CITY OF ALBUQUERQUE

**RE: 5730 McMahon Blvd NW –McMahon Market Place New Shell Building
Grading Plan
Stamp Date: No Stamp Date
Hydrology File: A11D011E**

CG-1

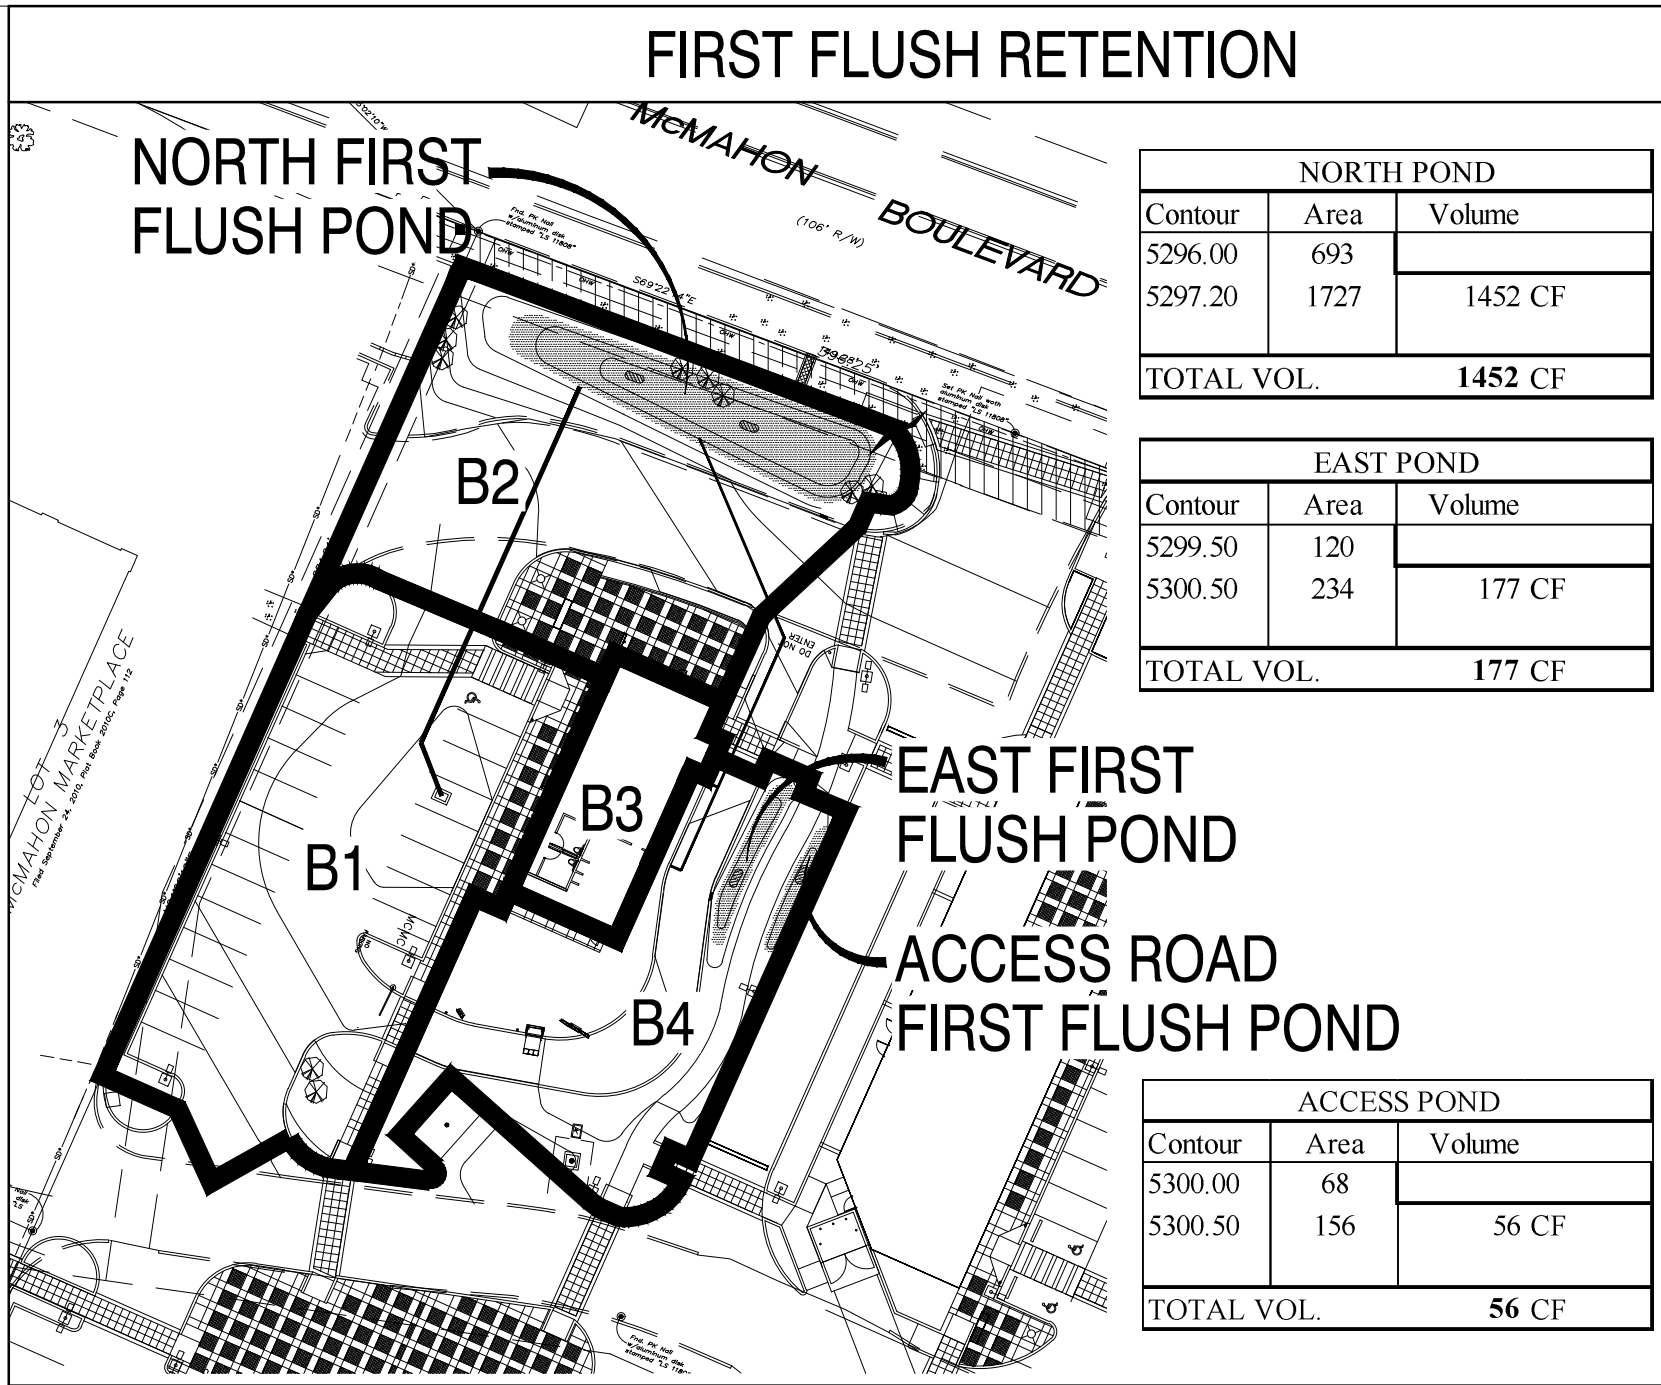
1. On Sheet CG-1 & CG-2. Please provide an engineer's stamp with signature & date.

2. On Sheet CG-1. Please make the existing spot elevations readable. Checking the transition between proposed pavement and existing pavement is hard to do when the existing spot elevations are that small.

3. On Sheet CG-1. Please remove the future development along with any note letters and numbers. It is confusing in knowing what is being constructed, what is existing, and what is future development. Please clarify.

4. On Sheet CG-1. There is a proposed curb along a proposed drive or future drive on the east side of the property. It is hard to tell. If this is drive to be built with this submittal. If it is then a temporary curbing will need to be provided for where it has a future curbing. Please clarify.

5. On Sheet CG-1. There is a proposed curb along the exiting drive along the south property. Since it is noted that the existing asphalt drive is to remain, then is the south existing curb remaining or is there new curbing being installed. Please clarify.

6. On Sheet CG-1. There is an existing drive in the northern portion of the property. Is this to remain? The northern curb is to stay. If it is new then please show what the limits the existing drive is to be remove and what is to remain. If existing drive to remain, then there are proposed contours that should be tied into the existing drive contours instead. Please clarify.

7. On Sheet CG-1. There are two curb cuts for the first flush basin along the east drive. Are both curb cuts needed? It appears that the drainage from this drive enters the basin, was this basin sized to handle this flow? Please clarify.

8. On Sheet CG-1. There are easements shown. Please label the easements.
9. On Sheet CG-2. Under the Drainage Plan Concept, The McMahon Marketplace DMP is called out. This plan used 5% Type B, 10% Type C, and 85% Type D. This plan also calls for the commercial tracts are permitted free discharge as long as the future development detains the 8.4 cfs for the entire 12.13 AC McMahon Marketplace in either a pond or change the amount of landscaping (Type B) and impervious (Type D) amounts. The Unser/McMahon Area DMP, 2001 by Bohann-Huston calls for 90% Type D and 10% Type B. Please update this section. **This site will be able to free discharge under the McMahon Marketplace DMP,** however Lots 5-A, 6-A, 8-A, 9-A, 9-B, 9-C, and 9-D will have to follow the McMahon Marketplace DMP and detain the 8.4 cfs in a pond.

SHEET NO:
CG-2

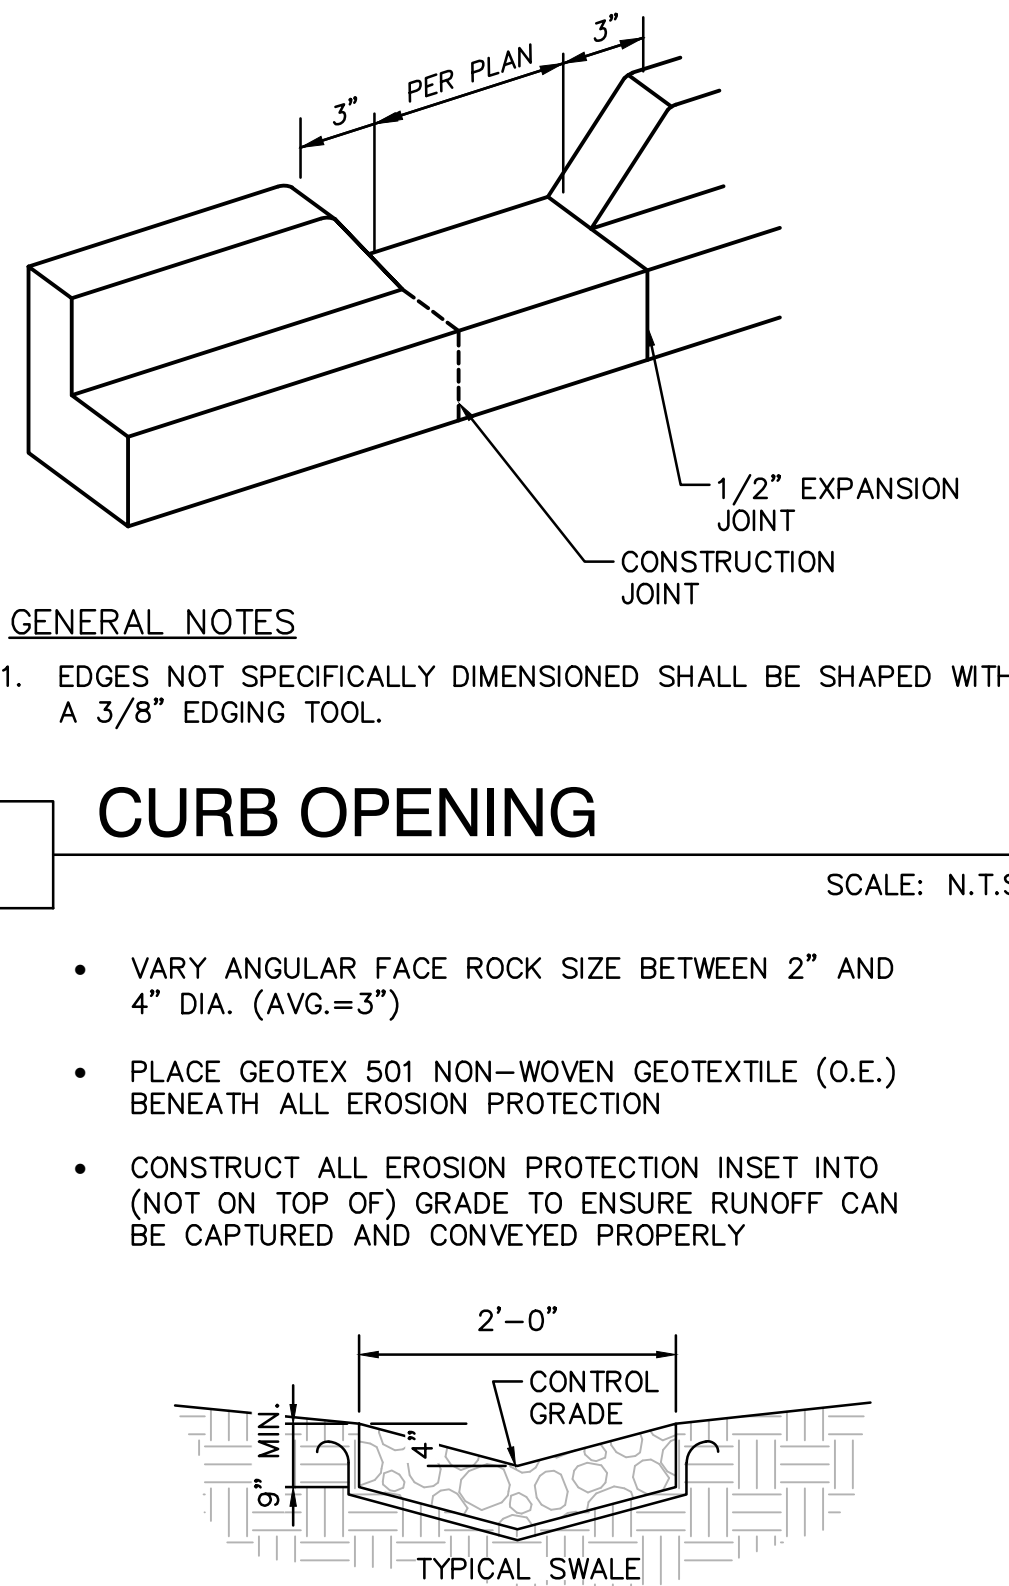
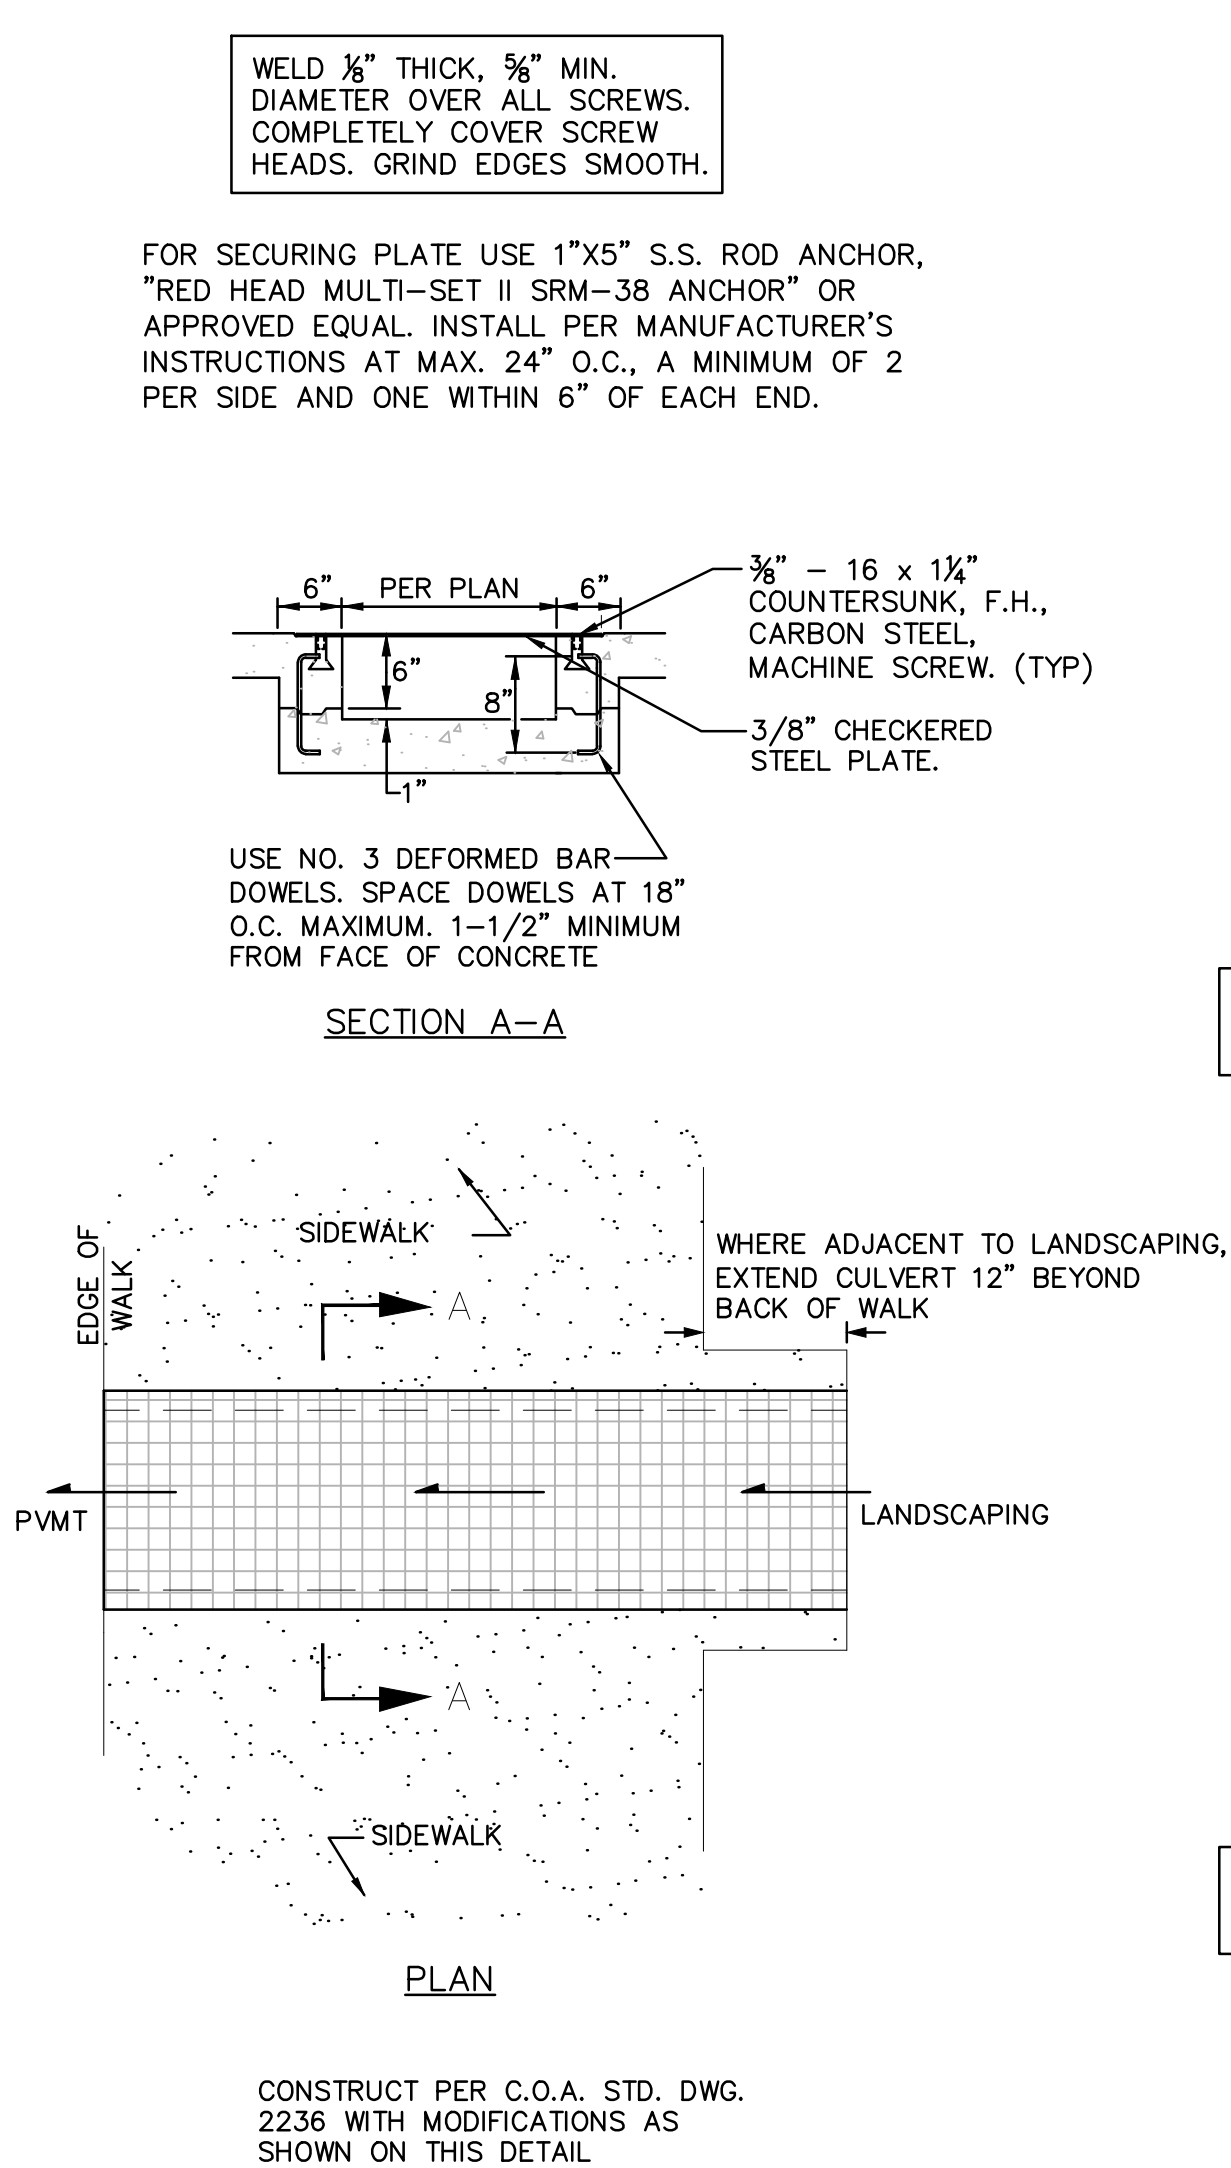
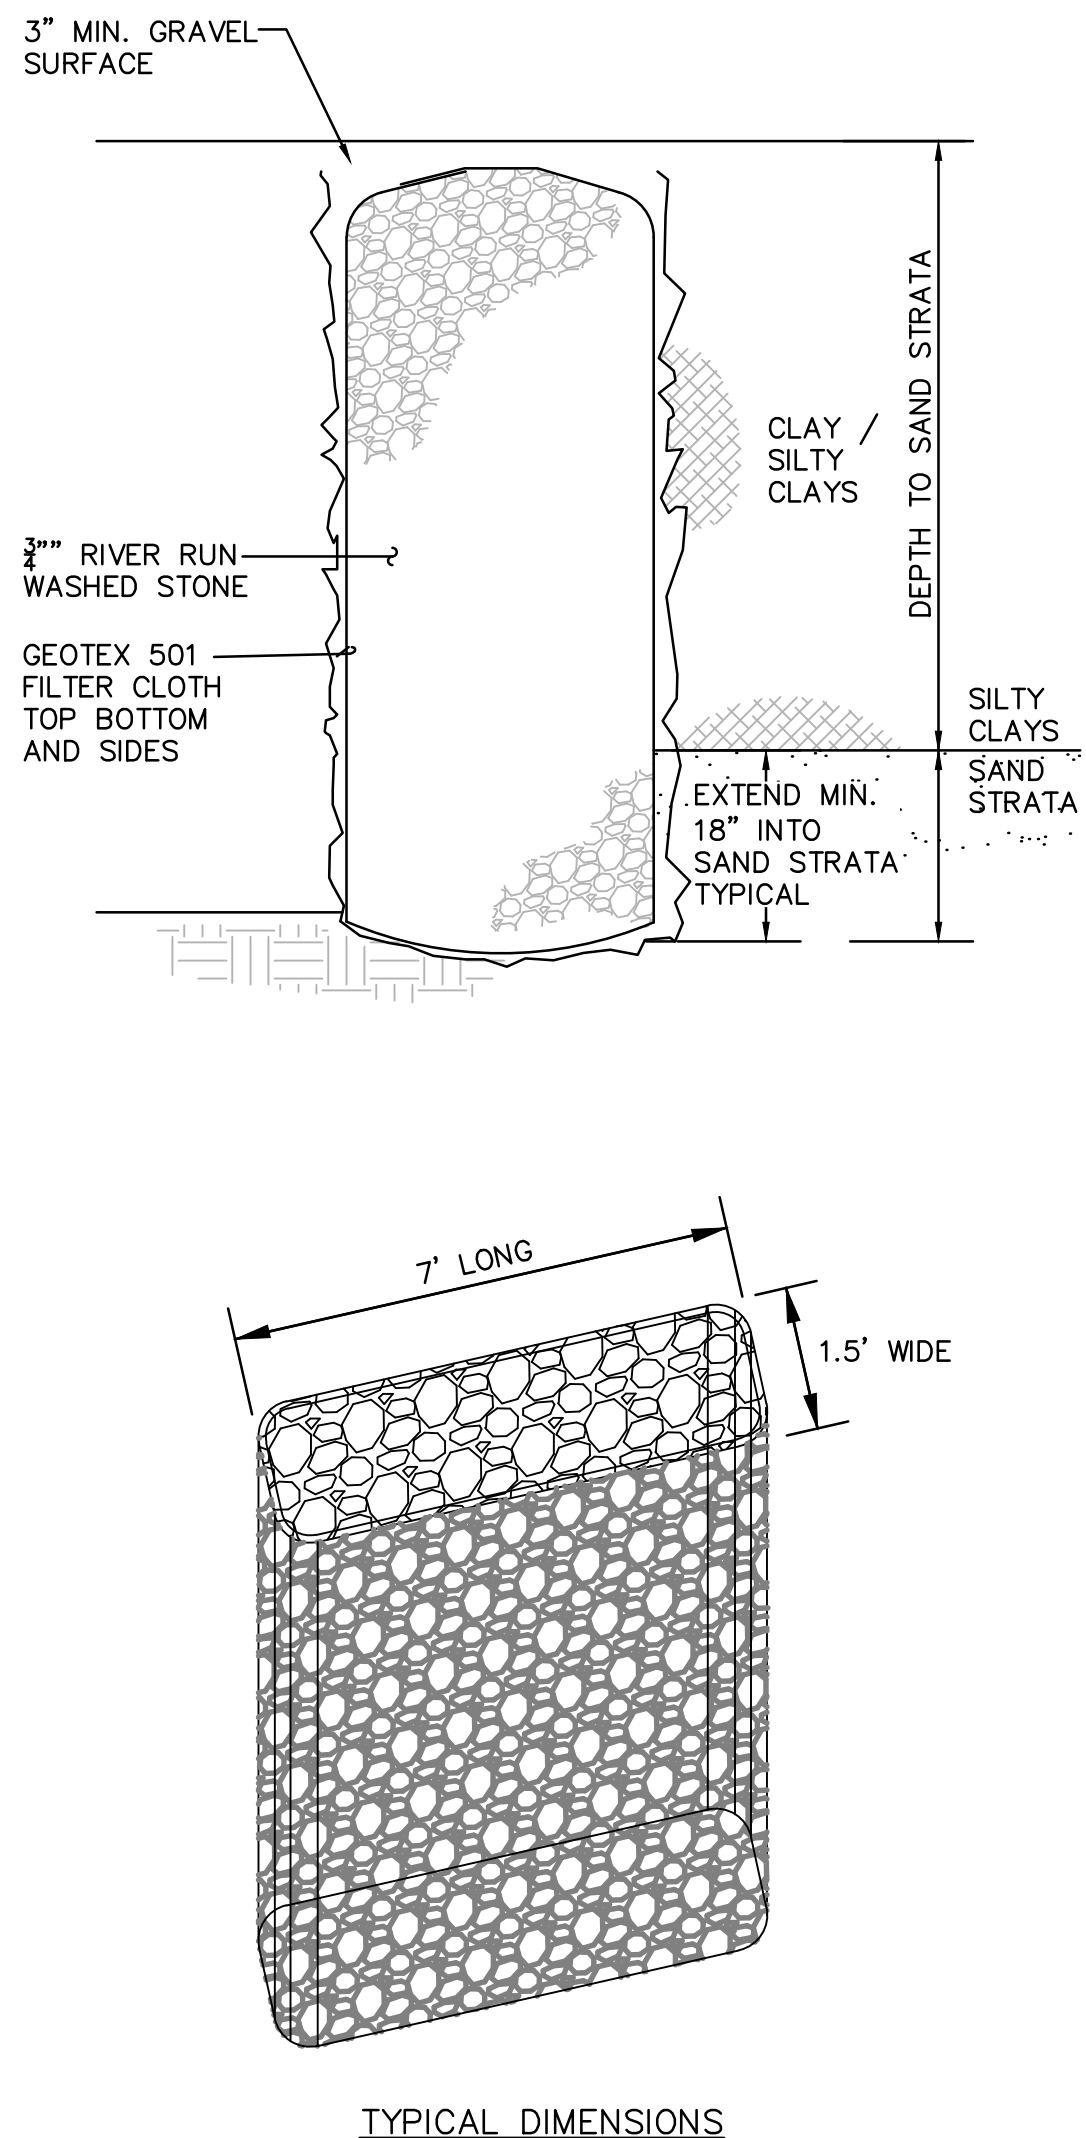
10. On Sheet CG-2. Please provide the weir calculations for the 24"; curb cut.
11. On Sheet CG-2. Please provide the weir calculations for the sidewalk culvert.
